Planning Committee

Wednesday 04 November 2020

Late Observations Schedule

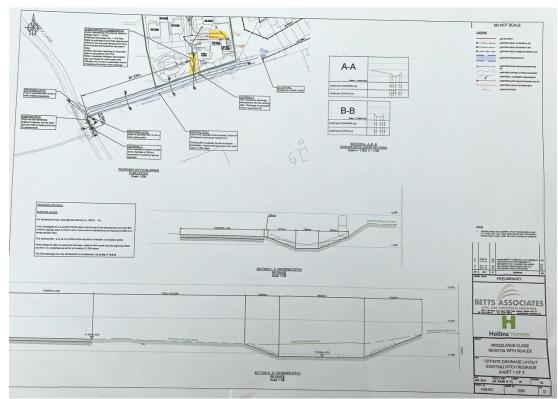
The officer's report has failed to consider evidence of issues with drainage, merely stating that there is "no evidence to support".;

The report states -"Perceived lack of downstream capacity" - "no evidence to support" (page 62).

Evidence has been provided through photographs many times to highlight the problem with flooding on Parrox Lane in the vicinity of the proposed surface water outfall. Also a statement from the landowner of the field on the western side of Parrox Lane into which the culvert / pipe exits, demonstrates further concern relating to flooding in that the downstream capacity is insufficient for either OLD or WCD. We ask that the downstream capacity be properly evaluated by the developer and these concerns addressed. If sufficient capacity is not demonstrated, then an alternative solution for surface water drainage should be found prior to conditional approval. The pool network to the south west of this site into which the pipe eventually drains will also exacerbate problems already experienced in Freckleton further downstream as well as the villagers on Oak Lane, Grange Lane and then onto Thames Street. The water flooding down and bubbling up from the combined sewer on Grange Lane onto Thames Street on the last set of heavy downpours demolished a wall and flooded a garage. We do not believe that simply fixing the culvert as a result of the WCD will solve the problem.

With regard to the surface water drainage from the WCD into the northern perimeter of the OLD site, we would like to remind the Planning Committee that WCD diagrams (see below) have been provided showing the solution agreed by the authorities for the use of the occupation track (Sandy Gap) for the surface water scheme of the WCD. This authorises the creation of a wide open ditch with re-profiled sides. This issue is not mentioned in the OLD officer's report, and so there is no evidence that the impact of this has been considered or addressed. Condition 11 on the WCD required a timetable for the implementation of the solution be provided. We are not aware of any implementation timetable.

Drainage – Pages 61-63 of the committee report (under the subheading 'flood risk') address resident objections regarding drainage – specifically within the final 3 paragraphs on p. 62 and the first 2 paragraphs on p. 63. In particular, it should be noted that:

- The surface water drainage strategy for the Woodlands Close development has already been approved as part of condition discharge application 18/0769 in consultation with the LLFA (who have also granted land drainage consent). There is, therefore, no opportunity (or need) to revisit this issue as part of this application for development on a different site.

- Neither the LLFA nor UU have raised any objections to the indicative drainage strategy set out the Flood Risk Assessment and a suitable condition has been imposed to control the detailed design of the final drainage scheme. There is, therefore, no reason to conclude that the indicative drainage scheme would result in any conflict with policies CL1 or CL2 of the Fylde Local Plan to 2032.

- Existing surface water flooding issues on Parrox Lane arise due to the presence
 of a fractured pipe within the culvert that runs under the road and a damaged
 headwall flowing into that pipe. These issues are to be rectified through the
 construction of a new headwall and installation of a replacement pipe to repair
 the culvert as part of the surface water drainage strategy for the Woodlands
 Close development approved by condition discharge application 18/0769.
